IEC/PAS 61162-101

**Part 101:
Single talker and multiple listeners –
Modified sentences and requirements
for IEC 61162-1**

PUBLICLY AVAILABLE SPECIFICATION

5.2 ACK – Acknowledge Alarm

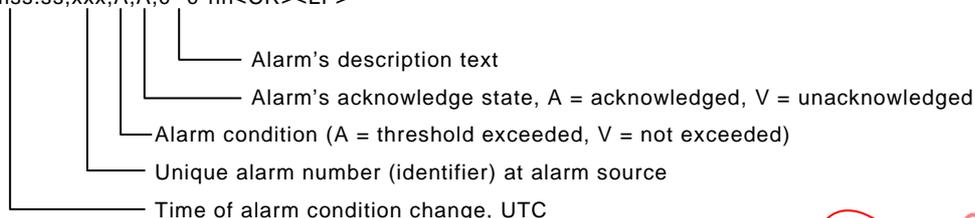
Updated the text label for the data field.

\$--ACK,xxx*hh<CR><LF>

└ Unique alarm number (identifier) at alarm source

5.12 GST – GNSS pseudorange noise statistics

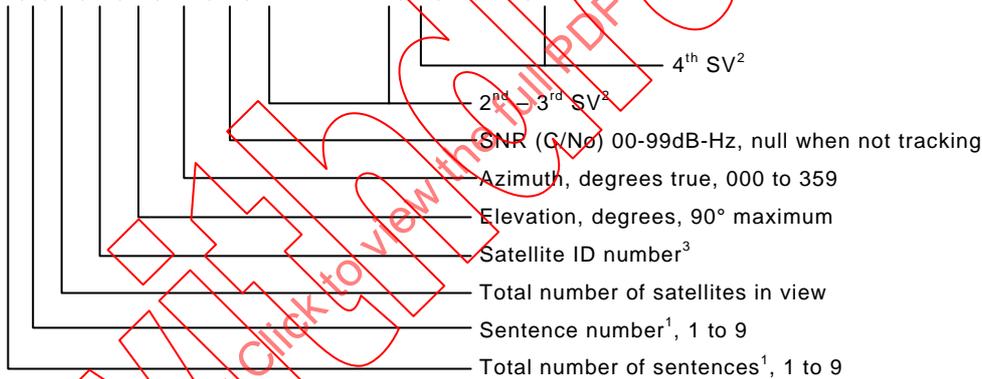
Amend the word "message" in the opening paragraph to "sentence".

5.21 XDR – Transducer Measurements

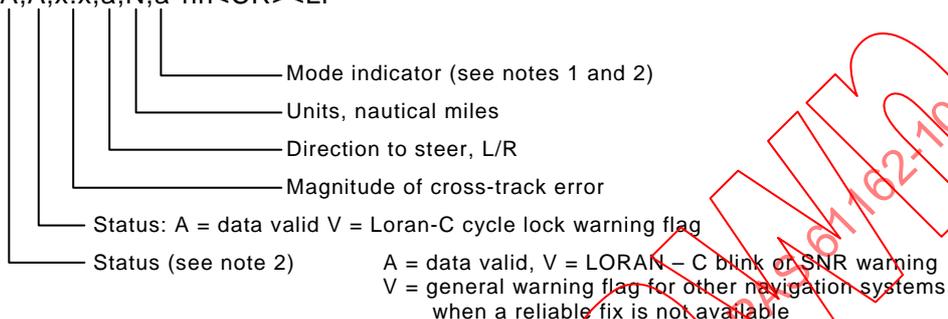
An additional transducer type has been added to the XDR sentence to support salinity measurements.

Additional note:

Add the unit definition to Table 3 of IEC 61162-1 – Character symbol table

NOTE 2 Allowed transducer types and their units of measure are:

Transducer	Type Field	Units Field	Comments
Salinity	L	S = ppt	ppt = parts per thousand
Absolute humidity	B	K = kg/m ³	kilograms per cubic metre

K Kilometers; km/hr; kg/m³

5.22 XTE – correction

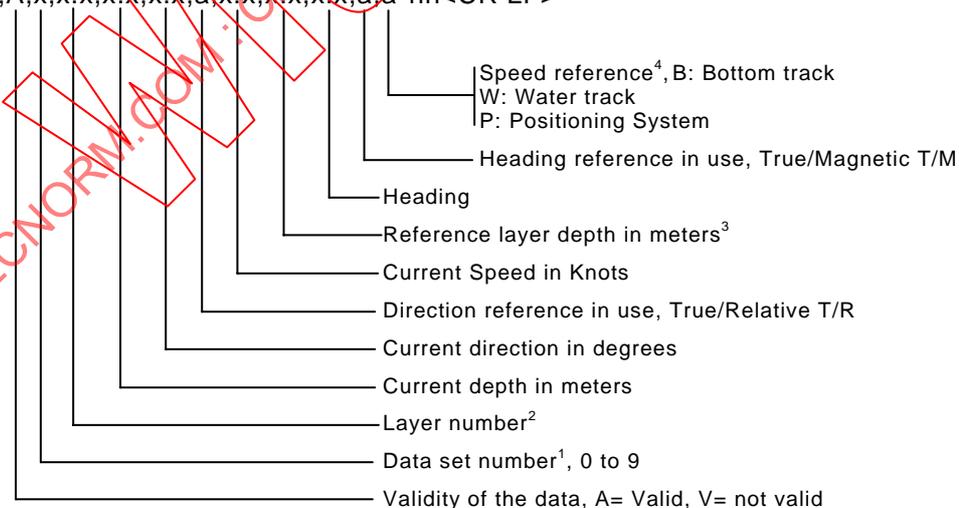
In Edition 2 of IEC 61162-1 there was a printing / format error in this sentence. The correct definition is given below.

XTE – Cross-track error, measured

Magnitude of the position error perpendicular to the intended track line and the direction to steer to return to track.

\$--XTE,A,A,x.x,a,N,a*hh<CR><LF

NOTE 1 Positioning system mode indicator :

- A = Autonomous mode
- D = Differential mode
- E = Estimated (dead reckoning) mode
- M = Manual input mode
- S = Simulator mode
- N = Data not valid

NOTE 2 The positioning system Mode indicator field supplements the positioning system Status fields (fields No. 1 and No.2); the status fields shall be set to V = invalid for all values of indicator Mode except for A = Autonomous and D = Differential. The positioning system Mode indicator and Status fields shall not be null fields.

6.2 GMP – GNSS Map Projection Fix Data

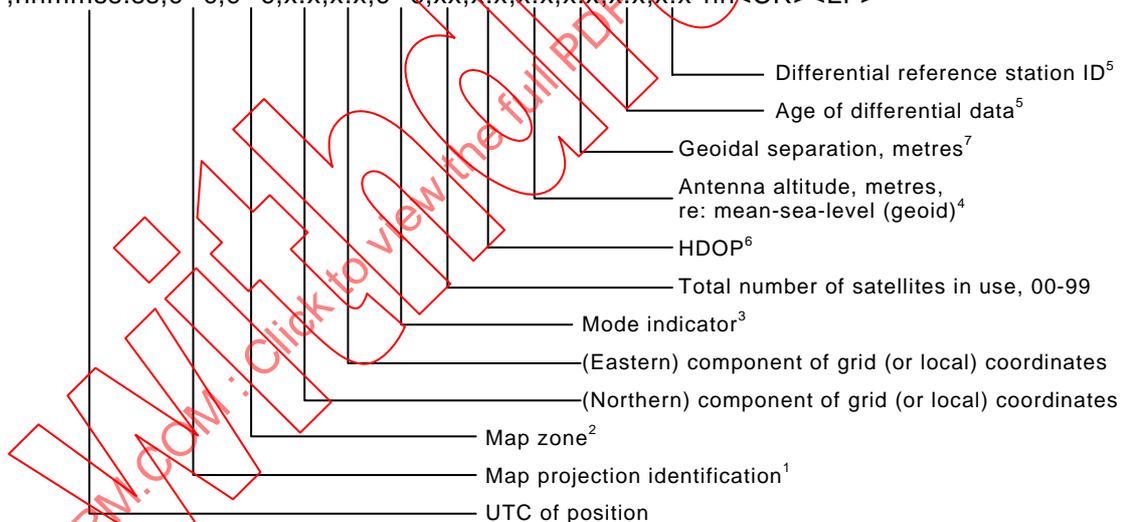
This new sentence has been created to support land use and provide map projection coordinates of any GNSS system.

\$--GMP,hhmmss.ss,c--c,c--c,x.x,x.x,c--c,xx,x.x,x.x,x.x,x.x,x.x*hh<CR><LF>

6.4 MWV – Wind Speed and Angle

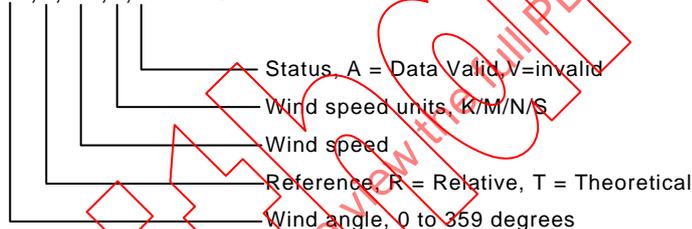
A new description has been added to the MWV sentence. This description attempts to clarify the use of this sentence, and describes the differences between apparent and true wind.

When the reference field is set to R (Relative), data is provided giving the wind angle in relation to the vessel's bow/centreline and the wind speed, both relative to the (moving) vessel. Also called apparent wind, this is the wind speed as felt when standing on the (moving) ship.

When the reference field is set to T (Theoretical / calculated wind), data is provided giving the wind angle in relation to the vessel's bow/centreline and the wind speed as if the vessel was stationary. On a moving ship these data can be calculated by combining the measured relative wind with the vessel's own speed.

\$--MWV,x.x,a,x.x,a,A*hh<CR><LF>

6.5 TUT – Transmission of multi-language text

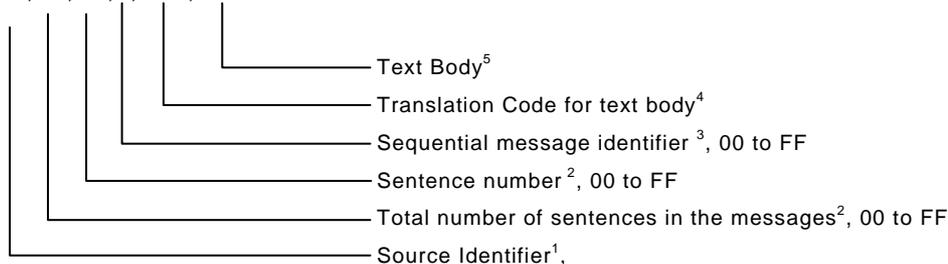
A new sentence created to support multi-language text. This is the first time that a variable length Hex field has been used in a sentence definition.

The sentence structure is similar to the TXT sentence, however it has two additional fields. There is a "Source identifier" field used to identify the origin of the sentence and a "Translation Code" field that is used to define the coding system for the text body. This enables the use of multi-language codes, such as, Unicode or other codes. A proprietary look-up table method is incorporated to allow pre-defined messages to be sent in short sentences.

\$--TUT,aa,hh,hh,x,c--c,h--h*hh<CR><LF>
